# **A12 Chelmsford to A120 widening scheme**

**TR010060**

## **DEVELOPMENT CONSENT ORDER CHANGE APPLICATION CONSULTATION**

### **10.14 Consultation Report Annexes**

*Updated B1023 roundabout design*

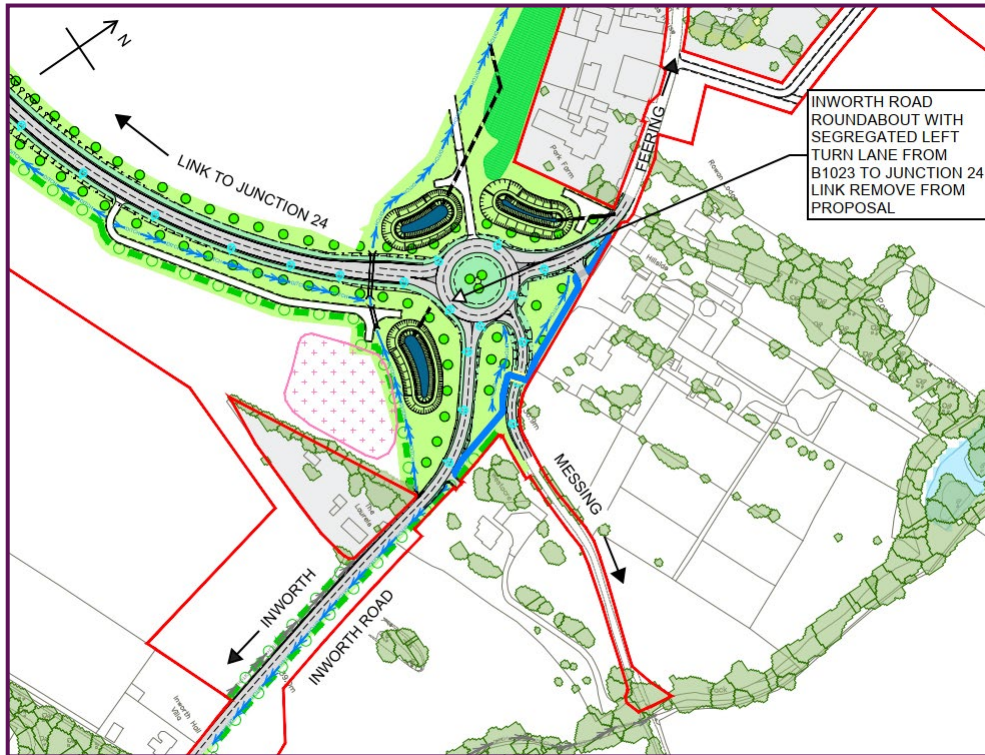
The Council have additionally noted that the entry to the roundabout from the B1023 northbound arm is shown as being marked for two lanes in the original scheme drawings (plate 1.1 in the technical note), whereas in the revised scheme drawing (plate 1.2 in the technical note) this marking is absent, indicating a single lane entry. We would request confirmation that this change has been reflected in the updated scheme modelling, as less traffic is theoretically able to enter the roundabout in this arrangement and we would as such expect there to be further impacts to delay values and queue lengths at this arm.

General Arrangement Plan Sheet 2 of 21

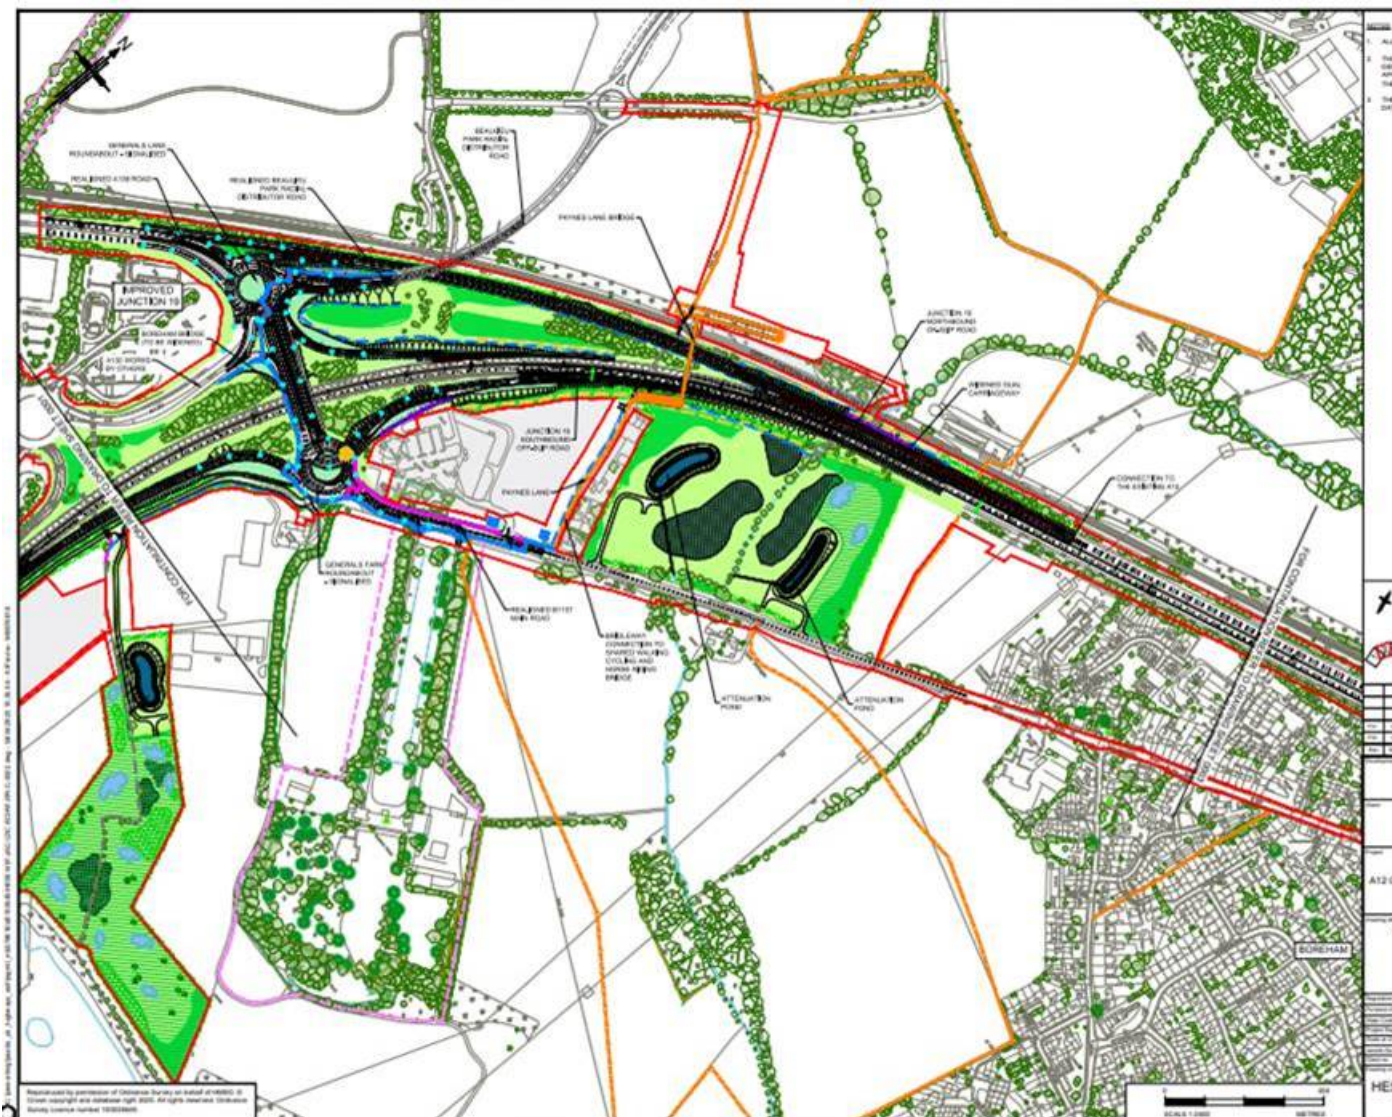
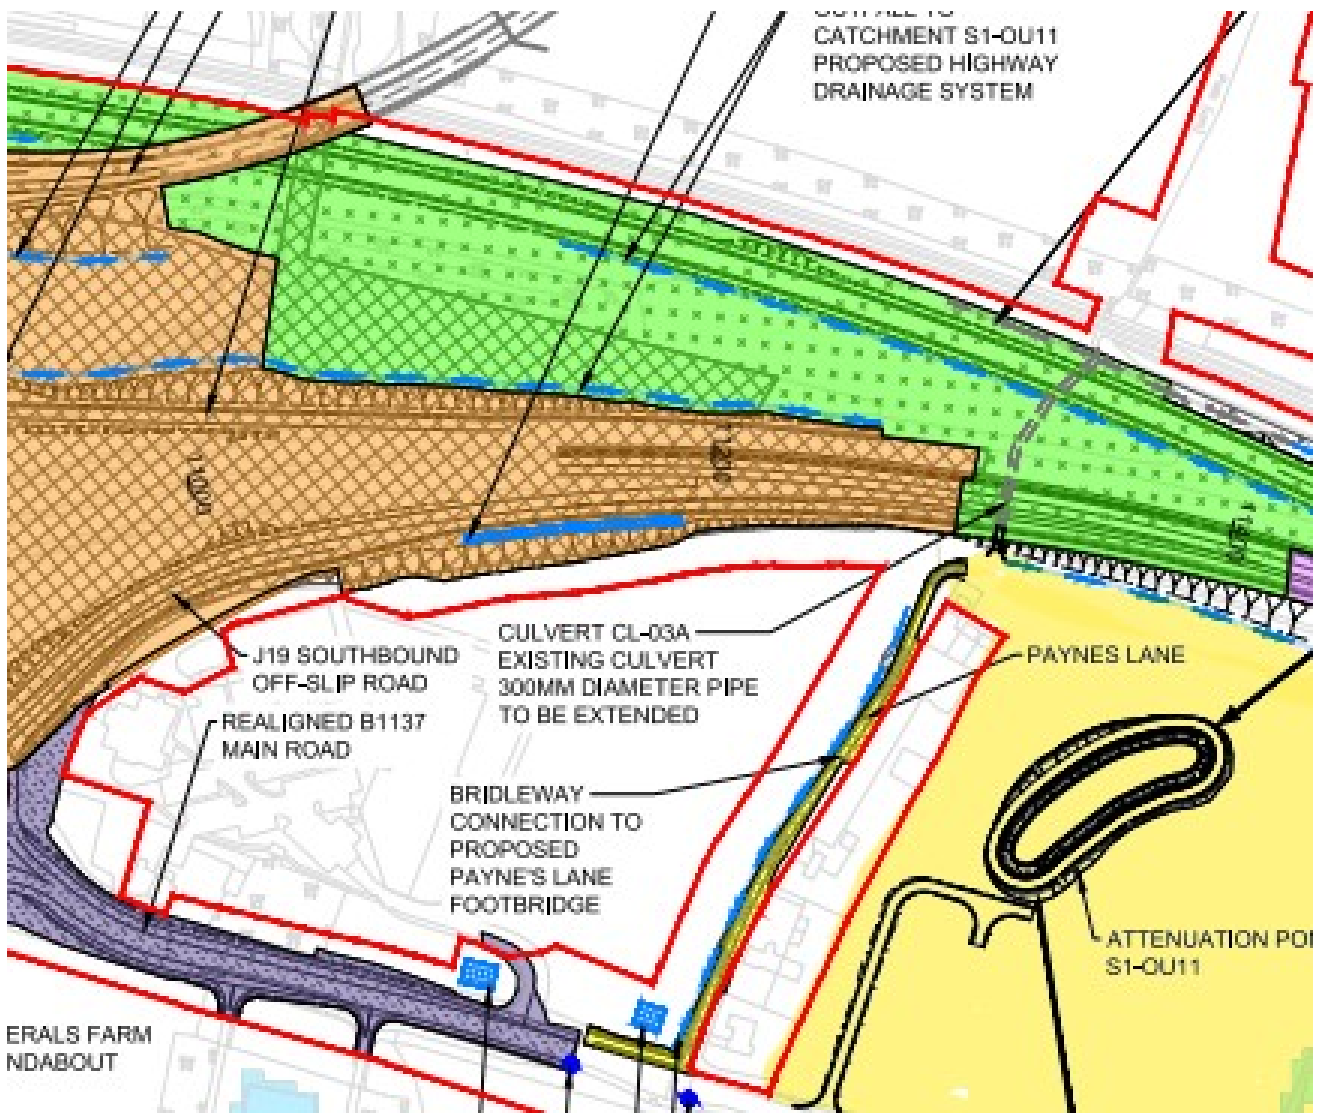
Our client has previously set out an objection to the Scheme based on the extent of land acquisition and allocation of ecological mitigation (not limited solely to these grounds).

Our question now is does the variation to Junction 19 slip road affect the extent of land take currently identified for my client land to the north of Boreham Road? Specifically it is my understanding that this change may alter drainage requirements and the need for attenuation pond ref S1-OU11 (as approx. highlighted yellow below). In turn if not required would this further reduce the land take and non-essential mitigation identified over this area. Our client would welcome this reduced land take as a result of this alteration.
